Well Name: BENSON SHUGART	Well Location: T18S / R30E / SEC 26 / SESE /	County or Parish/State: EDDY / NM
Well Number: 12	Type of Well: OIL WELL	Allottee or Tribe Name:
Lease Number: NMNM025503	Unit or CA Name: BENSON SHUGART WATERFLOOD	Unit or CA Number: NMNM88499X
US Well Number: 300152052900S1	Well Status: Oil Well Shut In	Operator: CHEVRON USA INCORPORATED

Sundry ID: 2747167

Type of Action: Plug and Abandonment

Benson Shugart WFU #012 Proposed Wellbore Diagram

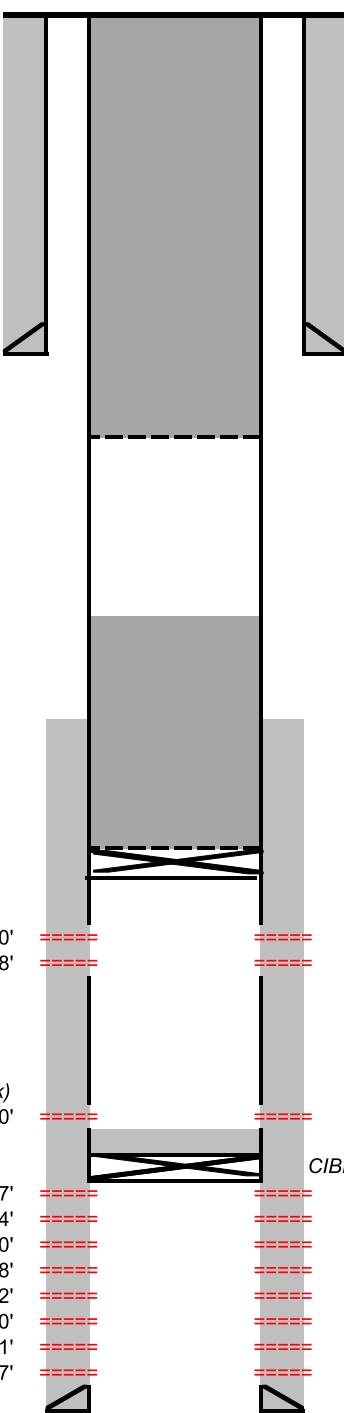
Perform CBL to confirm TOC in annulus and discuss w/ BLM

Plug Type	Top	Bottom	Length	Tag	Sacks	Cement Class	Notes
Surface Plug	0.00	100.00	100.00	Tag/Verify			
Fresh Water @ 92	41.08	142.00	100.92	If solid			
Top of Salt @ 669	612.31	719.00	106.69	Tag/Verify			
Shoe Plug	652.90	760.00	107.10	Tag/Verify	189.00	C	Perf and attempt squeeze from 760' to surface. (In 77 sxs/Out 112 sxs) Verify at surface.
Base of Salt @ 1667	1600.33	1717.00	116.67	Tag/Verify			
Yates @ 1867	1798.33	1917.00	118.67	If solid			
CIBP Plug	2180.00	2215.00	35.00	If solid base no need to Tag (CIBP present and/or Mechanic al Integrity Test), If Perf & Sqz then Tag, Leak Test all CIBP if no Open Perforatio ns	63.00	C	Set CIBP at 2215'. Spot cement from 2215' to 1600'.
Perforations Plug (If No CIBP)	2215.00	3080.00	865.00	Tag/Verify			
Shoe Plug	3472.42	3608.00	135.58	Tag/Verify
